Intersection ID: 32090	Main Street: JERPOINT_ABBY_DR	Cross Street: RATHANGAN_DR	Location:	NE
ADA ID: 60FAF023F446	Ramp Type: PerpDiag	Initial Pass/Fail: Fail	Overall Compliance: No	Severity Score: 25

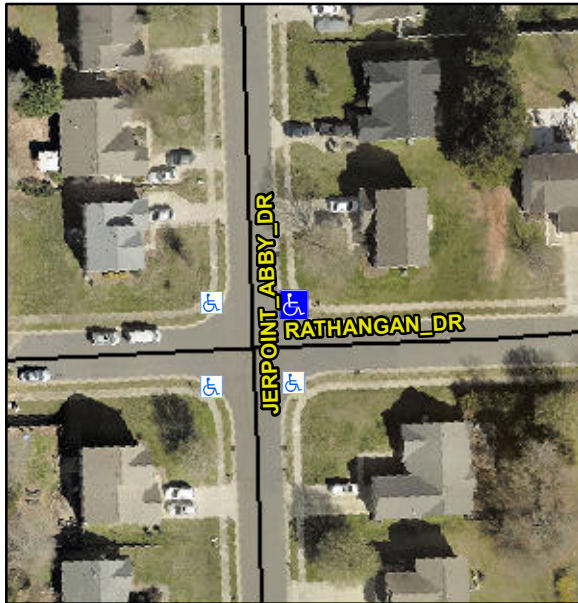
Compliance	Description	Data	Compliance	Description	Data
N/A	Ramp Length (in)	48.5	Yes	Ramp Slope (%)	5.4
Yes	Ramp Width (in)	48.0	No	Ramp XSlope (%)	7.1
N/A	Flare Type LT	N/A	N/A	Flare Type RT	N/A
N/A	Flare Slope LT (%)	N/A	N/A	Flare Slope RT (%)	N/A
N/A	Flare Traversable LT?	N/A	N/A	Flare Traversable RT?	N/A
N/A	Landing Length (in)	N/A	N/A	DWS Provided?	N/A
N/A	Landing Width (in)	N/A	N/A	DWS Contrast?	N/A
N/A	Landing Slope (%)	N/A	N/A	DWS Length (in)	N/A
N/A	Landing X Slope (%)	N/A	N/A	DWS Full Width?	N/A
N/A	Landing Curb? (Y/N)	N/A	N/A	DWS Offset (in)	N/A
N/A	Shared Landing?	N/A			
N/A	Gutter Ponding?	N/A	N/A	Gutter Slope (%)	N/A
N/A	Gutter Lip Ht (in)	N/A	N/A	Gutter X Slope (%)	N/A
N/A	Painted X Walk1?	No	N/A	Painted X Walk2?	No
	X Walk 1 Direction	To W		X Walk 2 Direction	To S
N/A	X Walk 1 Width (in)	N/A	N/A	X Walk 2 Width (in)	N/A
	X Walk 1 Slope (%)	2.6		X Walk 2 Slope (%)	2.8
	X Walk 1 X Slope (%)	4.6		X Walk 2 X Slope (%)	5.4

N/A	Ramp inside XWalk1?	N/A	N/A	Ramp inside XWalk2?	N/A
	Road Slope (%)	5.8	N/A	Clear Space?	N/A
	Road X Slope (%)	1.5	N/A	Clear Space to XWalk (in)	N/A
N/A	Any Obstructions?	N/A	N/A	Storm Grate/Utility Hazard?	N/A
	Obstruction Type			Storm Grate/Utility Type	
		N/A			N/A
			Yes	Surface Condition? (G/P)	Good

Remove & Replace Curb Ramp With Two New Directional Ramps or Equivalent.
